Albuquerque Bernalillo County
Water Utility Authority

Memo

To: Tom Berardinelli, Director of Staff, 377th Air Base Wing KAFB (via email)
From: Rick Shean, Water Quality Hydrologist, ABCWUA
CC: Mark Sanchez, Executive Director, ABCWUA; John Stomp, Chief Operating Officer, ABCWUA; James Bearzi, Hazardous Waste Bureau Chief, NMED; Will Moats, Project Manager, NMED-HWB
Date: 2/11/2011
Re: Review of *LNAPL Interim Measure Containment Work Plan for the Bulk Fuels Facility Spill, Solid Waste Management Units ST-106 and SS-111*, by Kirtland Air Force Base, dated November, 2010

Executive Summary

Figure 1. Proposed Containment System (taken from Interim Measure Containment Work Plan, November 2010)

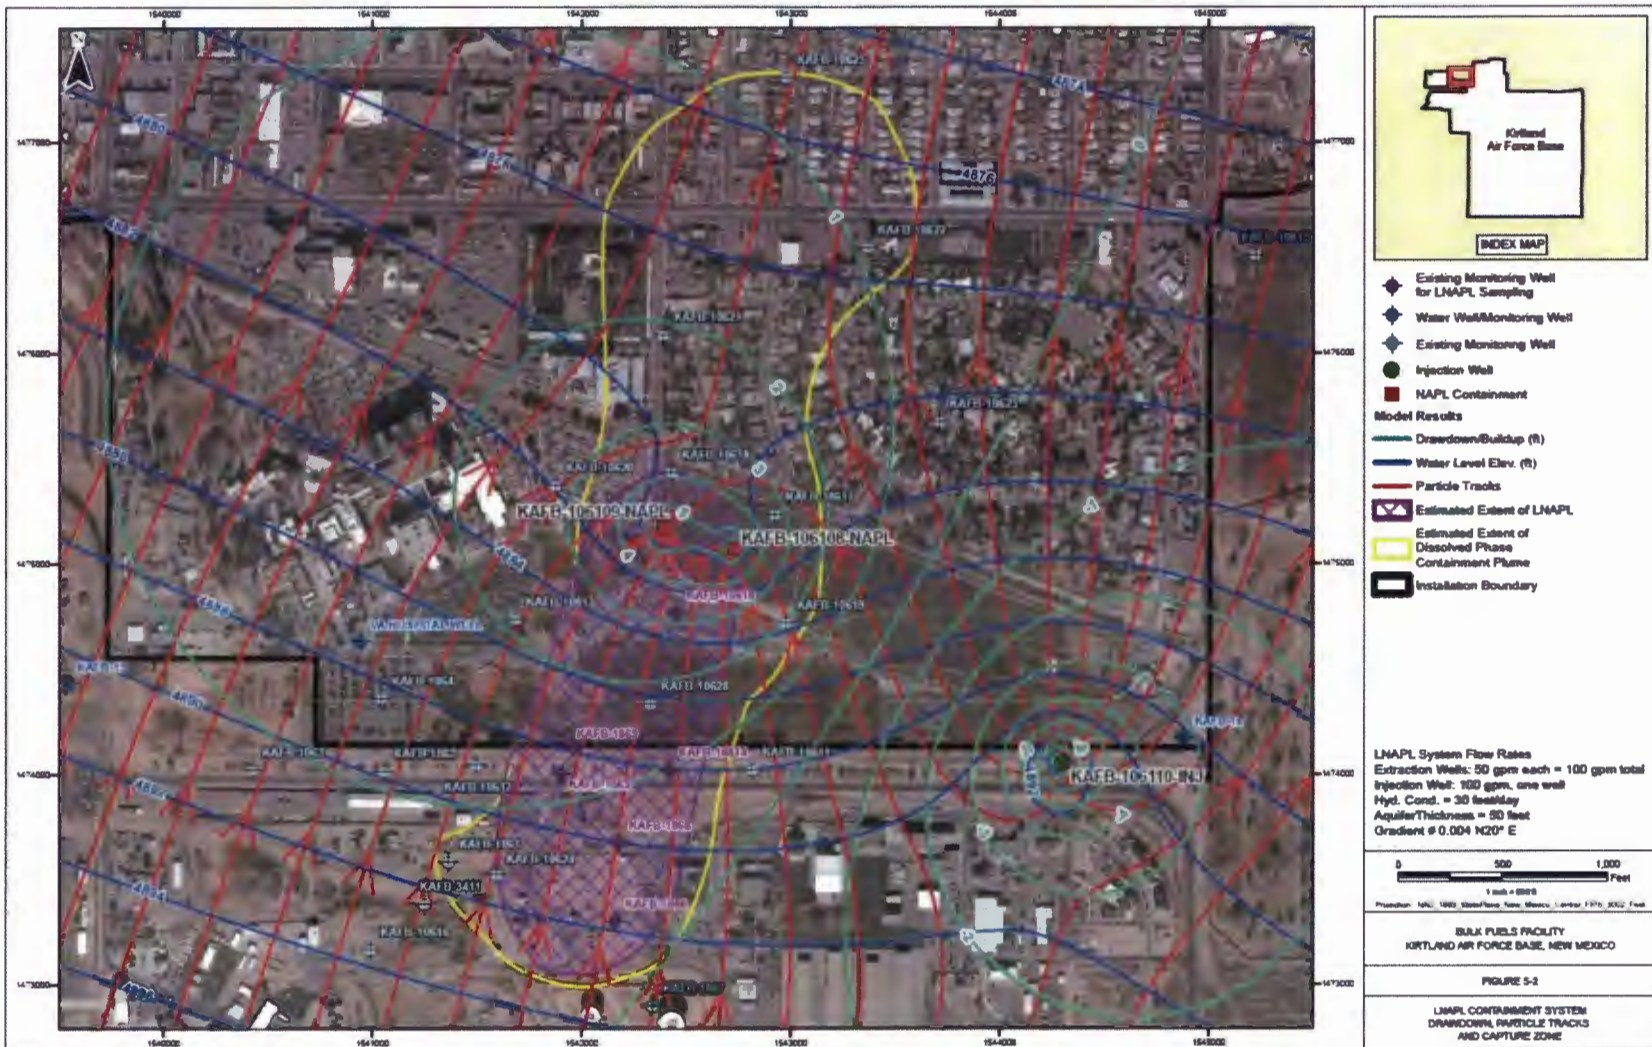
The proposed location and screened interval of the injection well raises the possibility that injection fluxes could accelerate the movement of dissolved phase contaminants to the downgradient public supply wells. In the absence of any groundwater quality data for the injection interval, assuming there is no contamination creates a risk of further compromising the aquifer. A major concern is that by locating the injection well cross-gradient from the known plume, treated water will be dispersed into a clean cell of the regional aquifer. Contaminated water will be introduced to a location where it currently does not exist. Also, there are no wells proposed down gradient of the injection wells to monitor either the resulting levels of contaminants or resulting injection fluxes. The WUA believes this proposed activity is counter to the purpose of the aquifer restoration effort we all want for our ratepayer's water resources.

Possible mitigation includes constructing the injection well with the longest screen length feasible or else placing the injection screen much deeper than the bottom of the extraction well screens. Mr. James Bearzi, Bureau Chief of the NMED's Hazardous Waste Bureau, however, indicated during the public meeting on January 12, 2011, that NMED will not accept a design unless the injection is upgradient of the extraction wells. The Water Authority supports the NMED's position on the injection well location.

2. Move location of proposed injection well upgradient of the interim containment system, so injected water can be potentially captured by the extraction wells.

Figure 2. Simulated Drawdown Contours for 100-Foot-Thick Aquifer

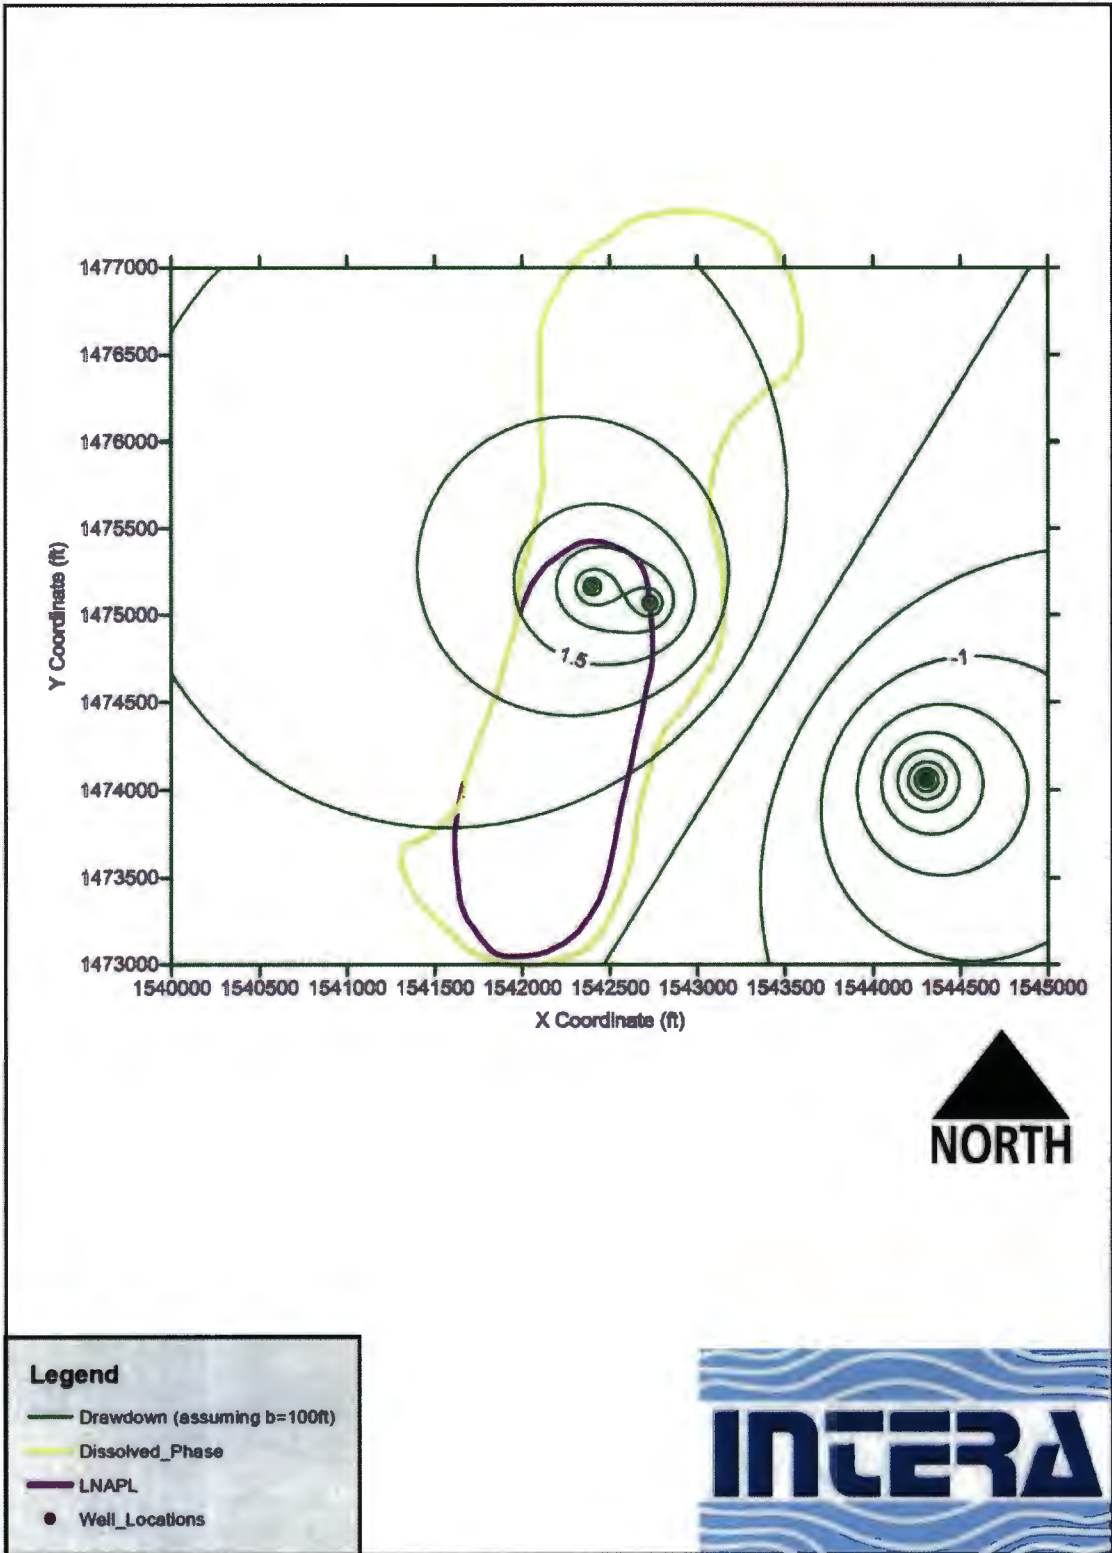
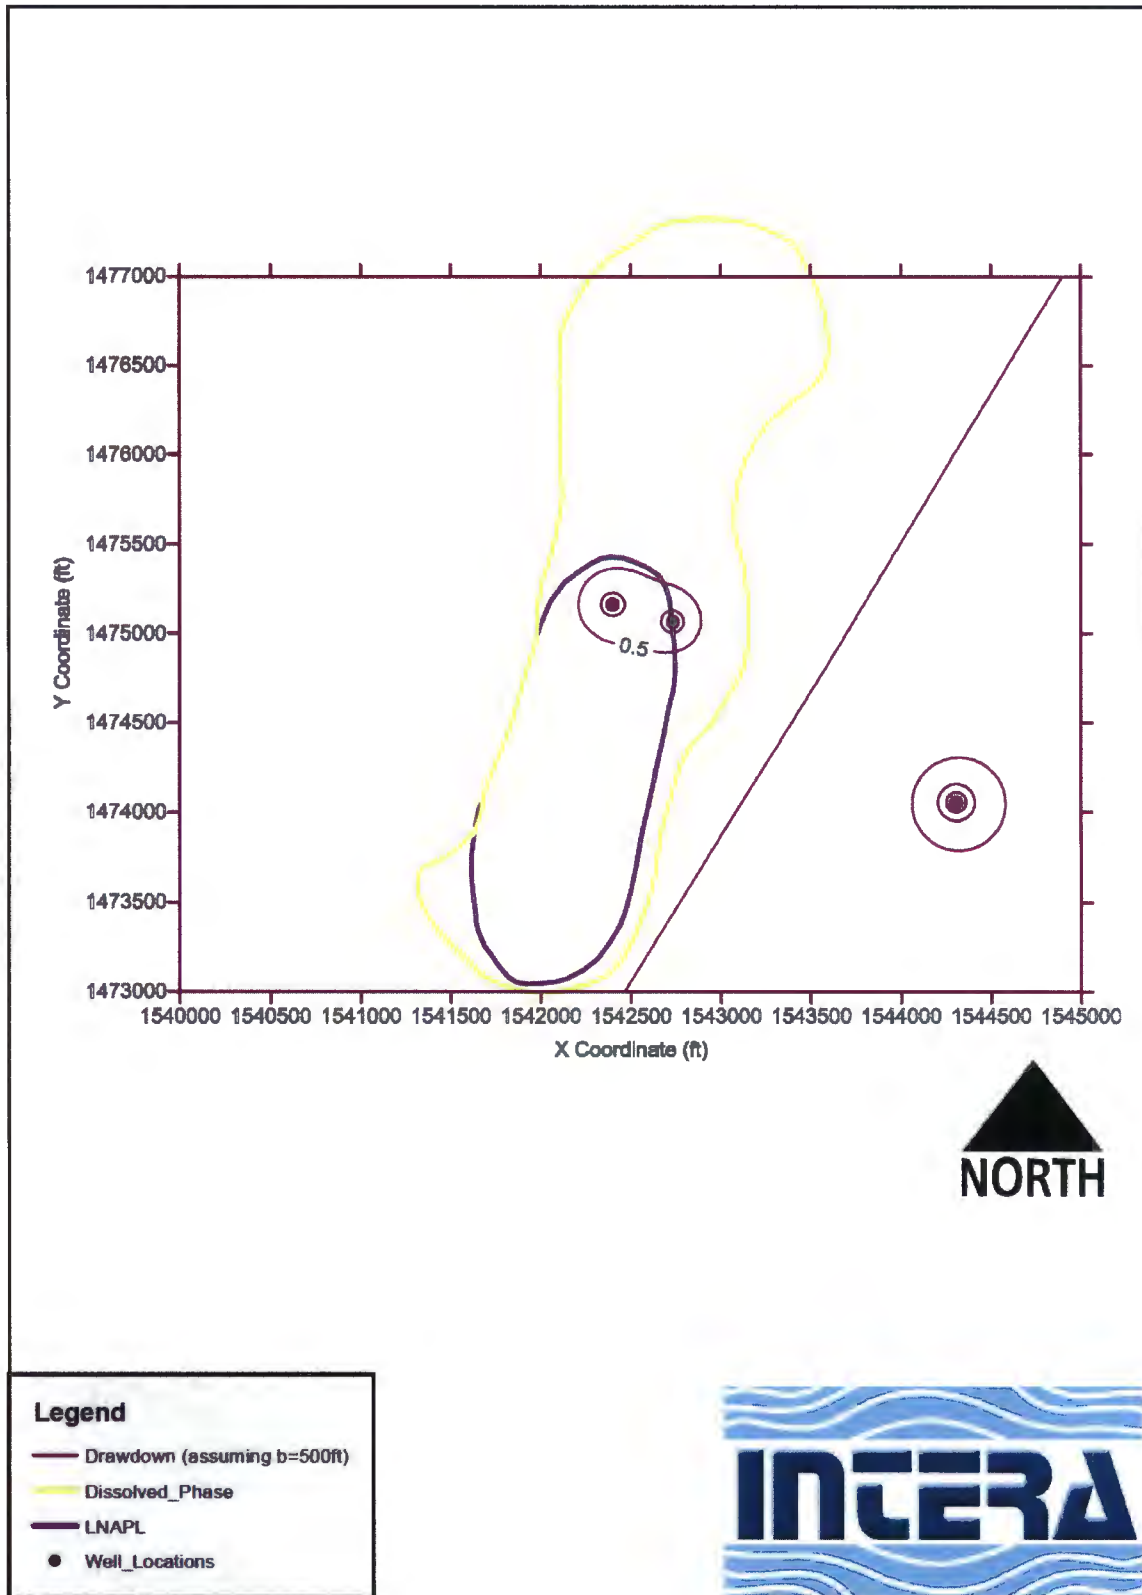
Our reviewers believe, as do we, that the true aquifer thickness is not 50 ft in the vicinity of the LNAPL lens. Several area production wells have screened intervals that are 500 ft bgs or greater. Since drawdown is inversely proportional to aquifer thickness, the work plan estimate is not sufficiently conservative. INTERA's simulated system shows drawdown to be roughly four ft at the downgradient edge of the LNAPL lens (Figure 1). They used the forward modeling tool in AQTESOLVE (HydroSOLVE, 2009) to simulate drawdown contours from the containment system using the same aquifer parameters and more realistic estimates of aquifer thickness, 100 and 500 ft. INTERA's analysis could not accommodate the regional hydraulic gradient, so the shape of the drawdown contours differs slightly from those in the KAFB work plan. With an aquifer thickness of 100 ft, drawdown was approximately 1.5 ft at the LNAPL edge, whereas the 500 ft thick aquifer yielded drawdown of 0.5 ft at the same location (Figures 2 and 3).

1. Use a more appropriate aquifer thickness in design simulations for the interim containment system. Explain the how the simulations of a 50-ft-thick aquifer accommodate a 100-ft screened interval for the injection well.
